# ADDENDUM No. 2: November 15, 2018

**PROJECT:** **Saint John the Baptist**
**Westbank Public Safety Complex**
**PROJECT NO.:** **STBA 21238.00**

**FROM:** SIZELER THOMPSON BROWN ARCHITECTS
300 Lafayette Street, Suite 200
New Orleans, Louisiana 70130
(504) 523-6472

1
E101
ELECTRICAL SITE PLAN
1" = 20'-0"

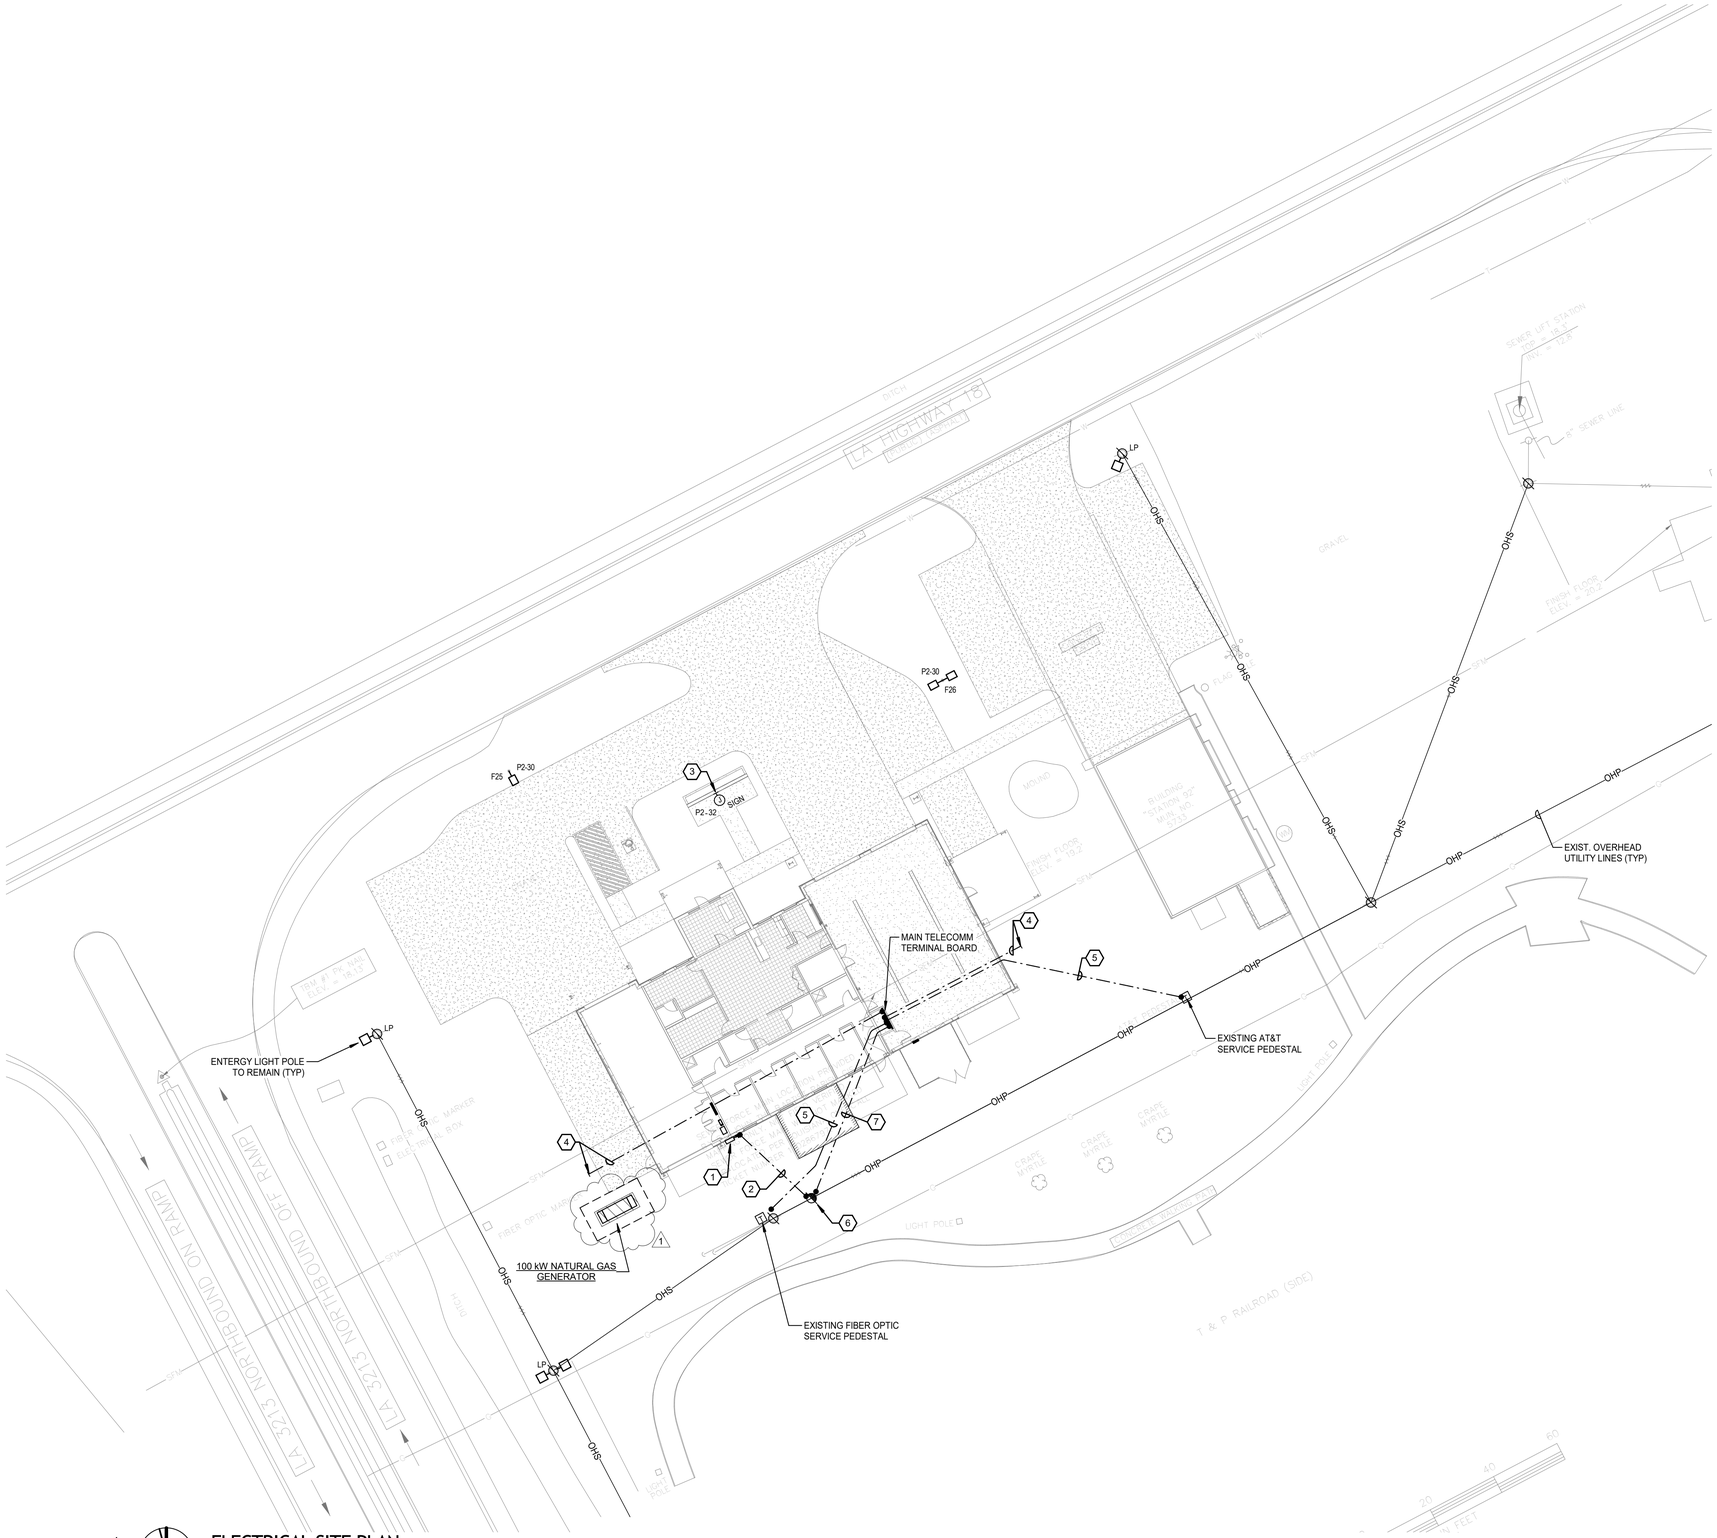
**25. <u>Sheet E101 Electrical Site Plan</u>**

1 E201 LIGHTING PLAN
1/8" = 1'-0"

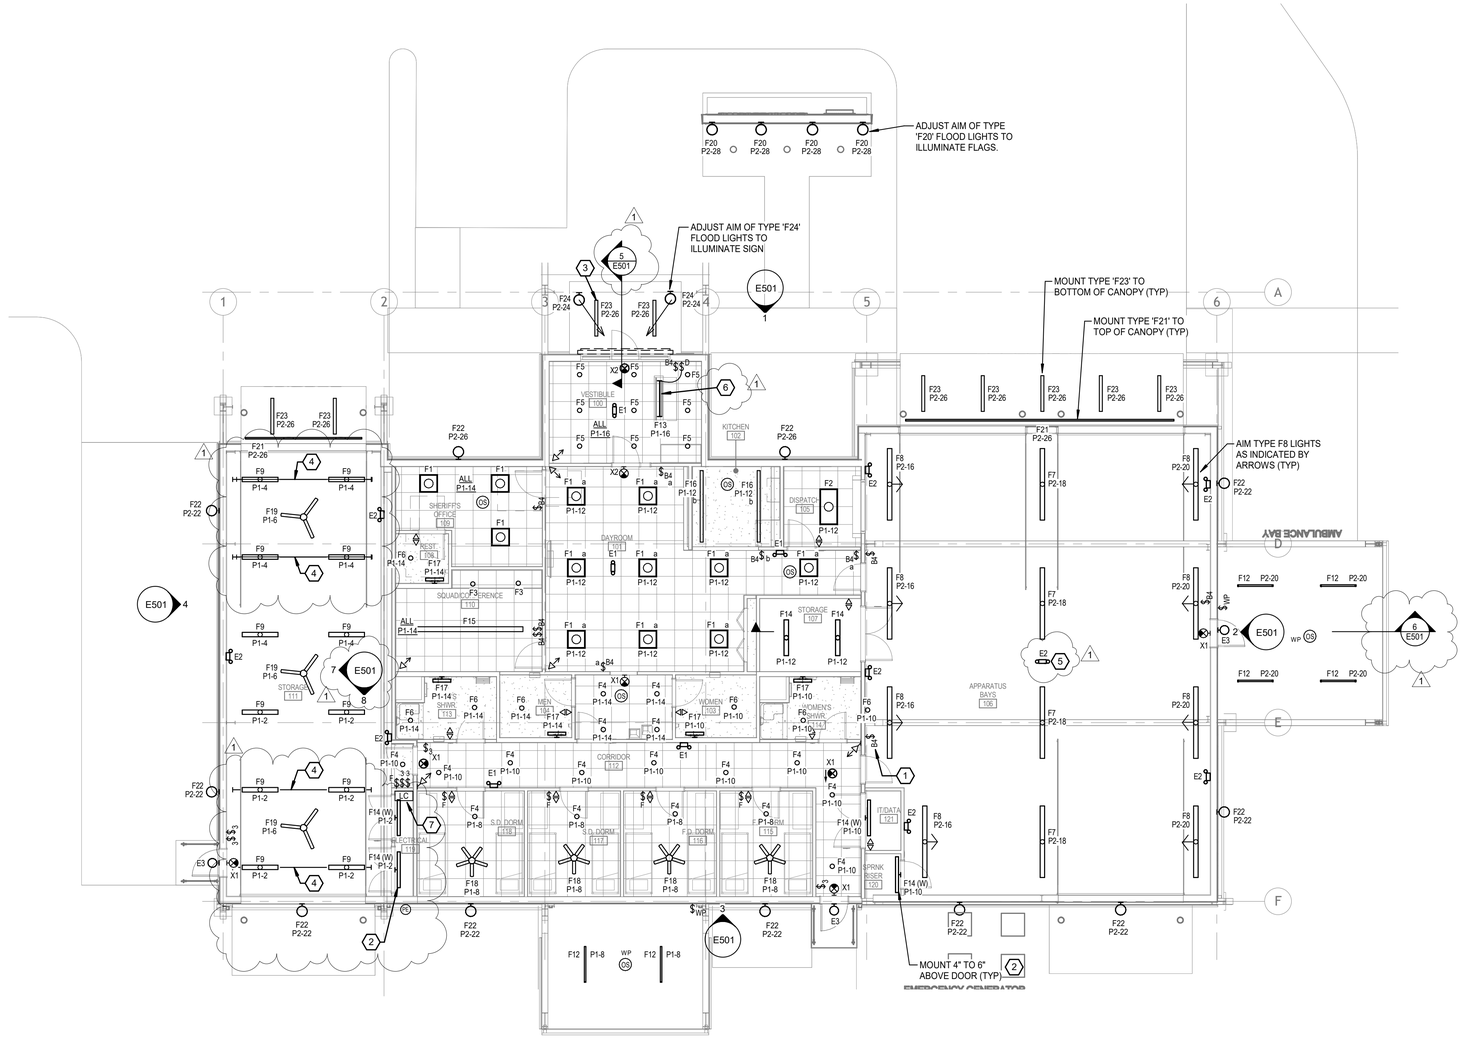
**26. <u>Sheet E201 Lighting Plan</u>**

a. Added information including Sheet Specific Note #4 to clarify installation of light fixtures in Storage 111.
b. Added Sheet Specific Note #5 to clarify installation of Type 'E2' in Apparatus Bays 106.
c. Added Sheet Specific Note #6 to clarify installation of Type 'F13' in Vestibule 100.
d. Added Location of Lighting Contactor, Time switch, and photo relay that control exterior lighting.

1 E301 POWER PLAN
1/8" = 1'-0"

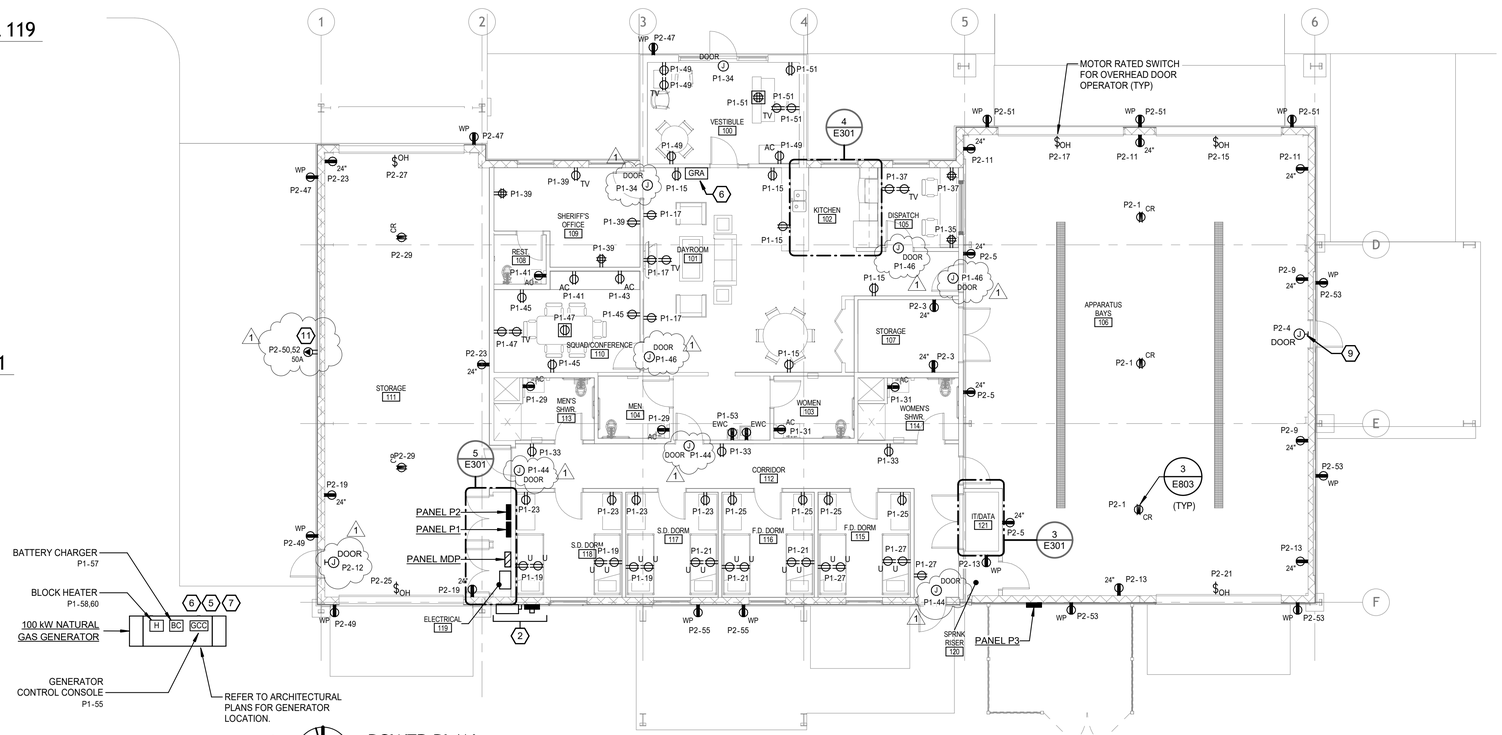
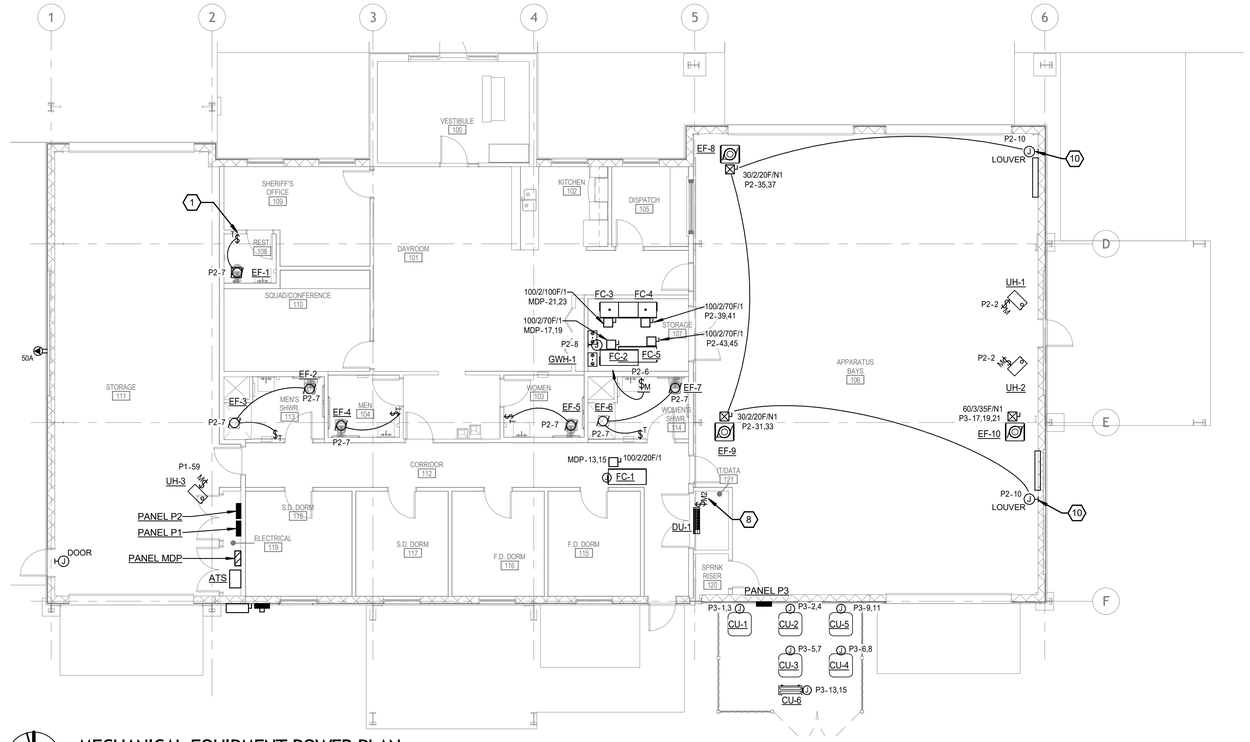
**27. <u>Sheet E301 Power Plans</u>**

a. Added 120V power at multiple doors for future access control system devices.
b. Added 50A receptacle on West exterior of building for Mobile Command Center power.

c. Added Sheet Specific Note #11.

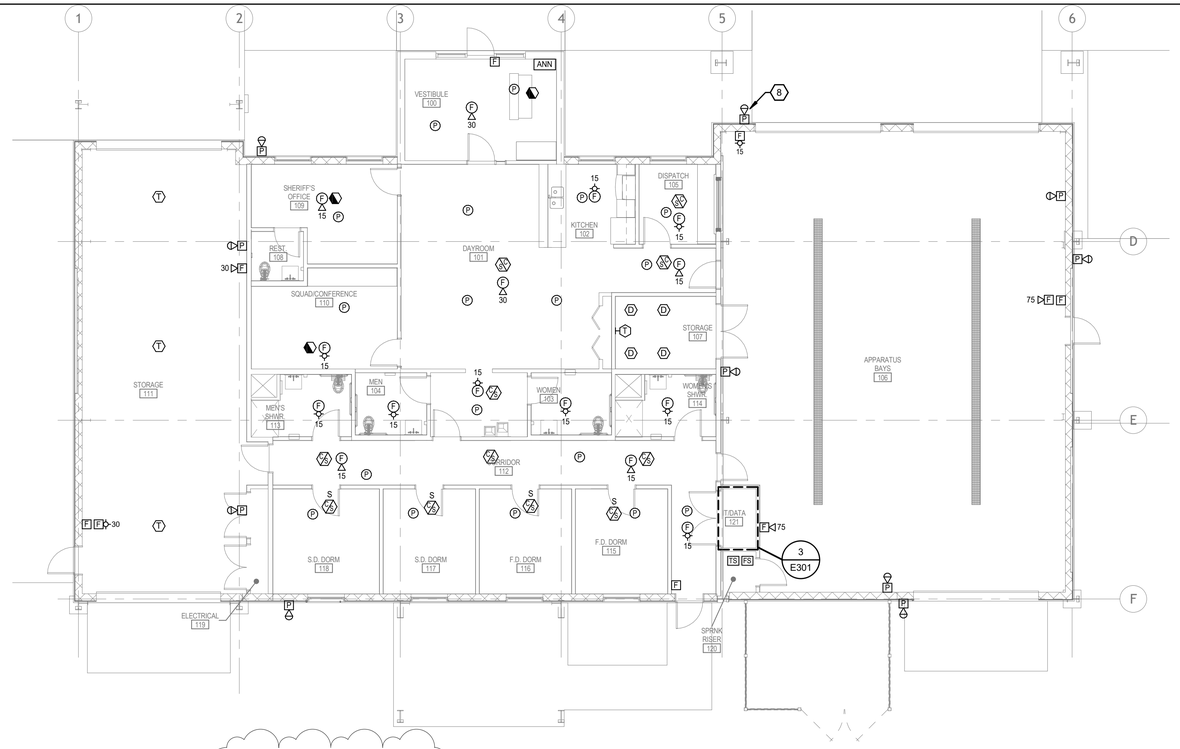
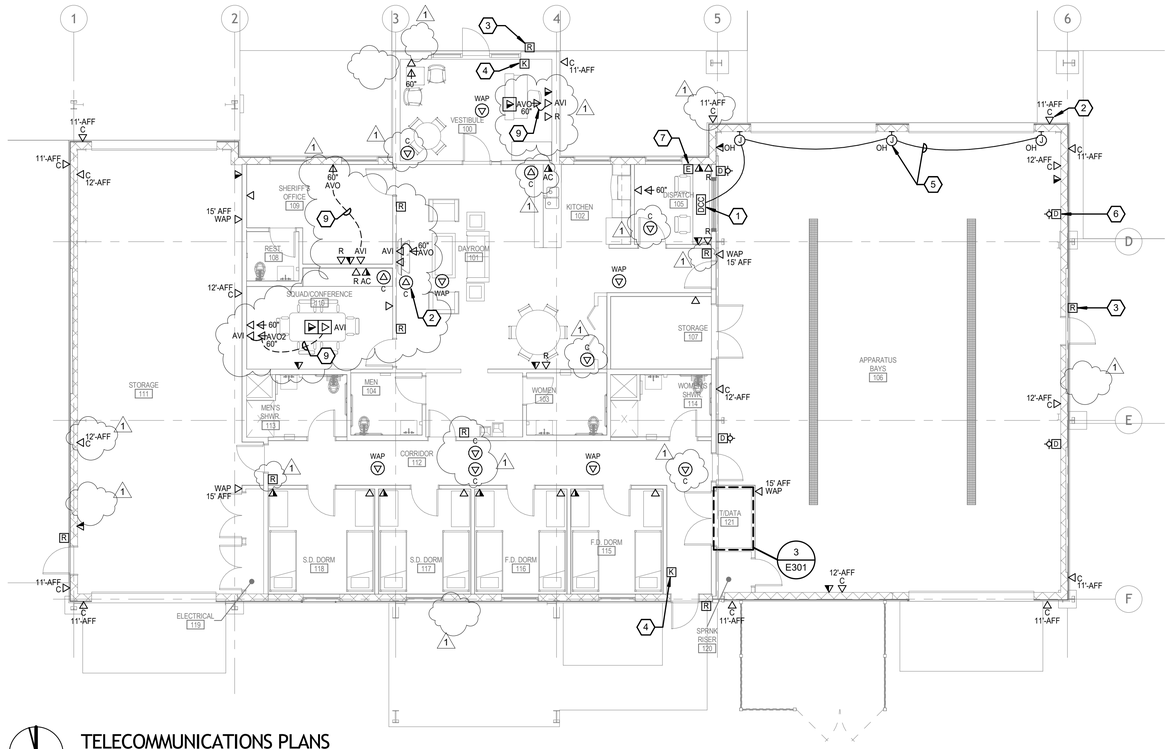
**28. <u>Sheet E401 Communications Plans Plan</u>**

a. Moved Intercom System devices to be shown on Fire Alarm Plan.
b. Renamed "Fire Alarm Plan" to "Fire Alarm and Intercom System Plan".
c. Revised quantities and locations of the CCTV Camera outlets.
d. Added Audio/Video provisions in Vestibule 100, Dayroom 101, Sheriff's Office 109, and Squad/Conference 110.
e. Revised Sheet Specific Note #2.
f. Added Sheet Specific Note #9.

8 E501 INTERIOR LIGHTING ELEVATION A - STORAGE 111
1/4" = 1'-0"

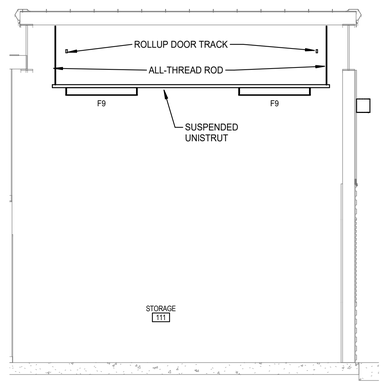
a. Added "Exterior Lighting Section – Front Sign"
b. Added "Interior Lighting Section – Apparatus Bay"
c. Added "Interior Lighting Elevation A – Storage 111"
d. Added "Interior Lighting Elevation B – Storage 111"

1 POWER RISER DIAGRAM
E601 N.T.S.

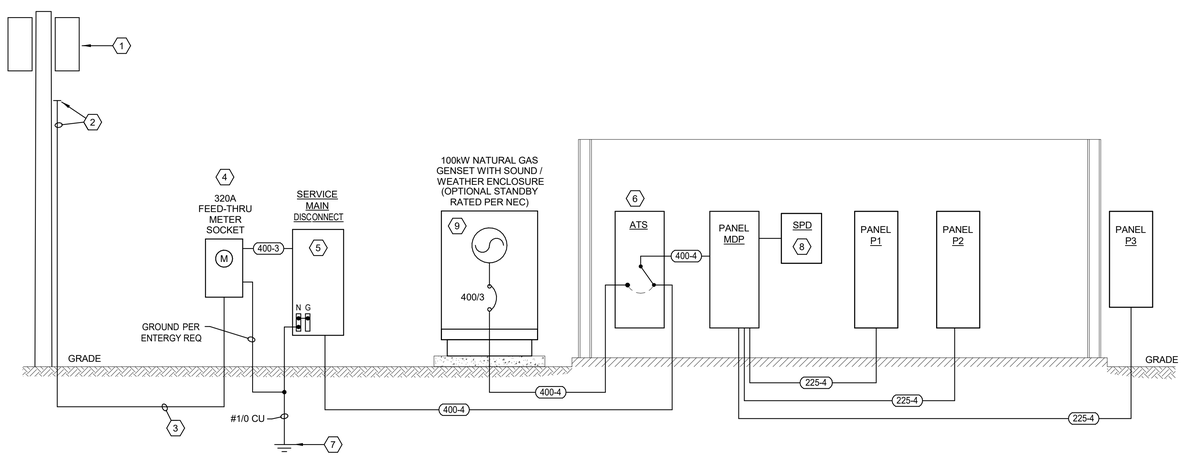
**30. <u>Sheet E601 Power Riser Diagram and Panel Schedules</u>**

a. Added branch circuits to Panels P1 and P2.
b. Added note to Power Riser Diagram clarifying that generator is to be provided by the Owner and Installed by the Contractor.

## 1 LIGHTING CONTROL SCHEMATIC - EXTERIOR LIGHTING
E802 N.T.S.

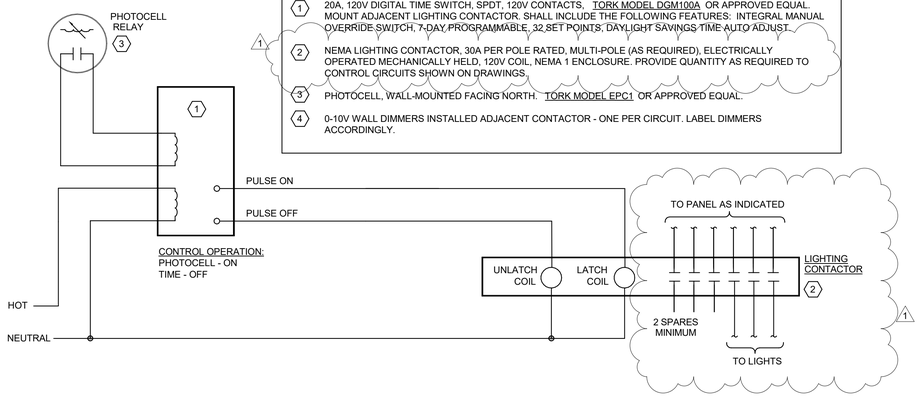
a. Revised "Lighting Control Schematic – Exterior Lighting"
b. Revised "Pole Base Wiring Diagram"

2 TELECOMMUNICATIONS OUTLET INSTALLATION DETAIL
E805 N.T.S.

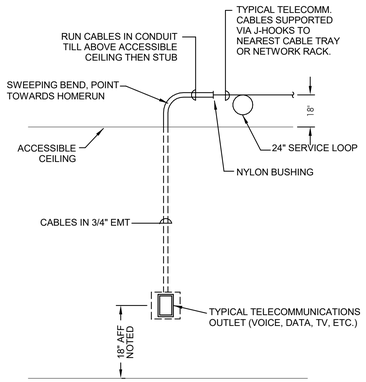
**32. <u>Sheet E805 Electrical Details</u>**

Added Outlets to the "Telecommunications Outlet Details" including those associated with A/V and CCTV camera provisions.
